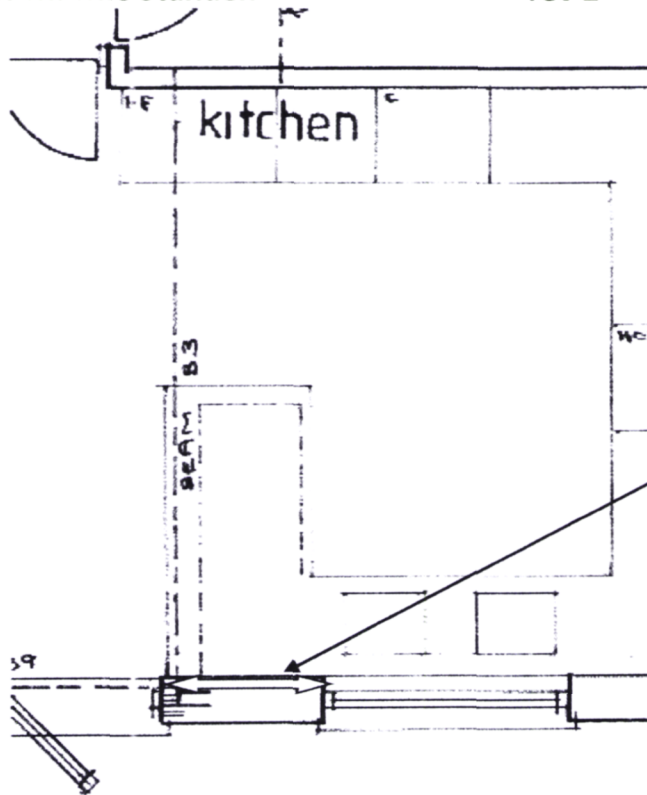
This section of inner skin wall to
be rebuilt in 7 Nmm strength
blockwork ie Thermalite Hi
strength 7 blocks (see **Structural**
note above, page 2)
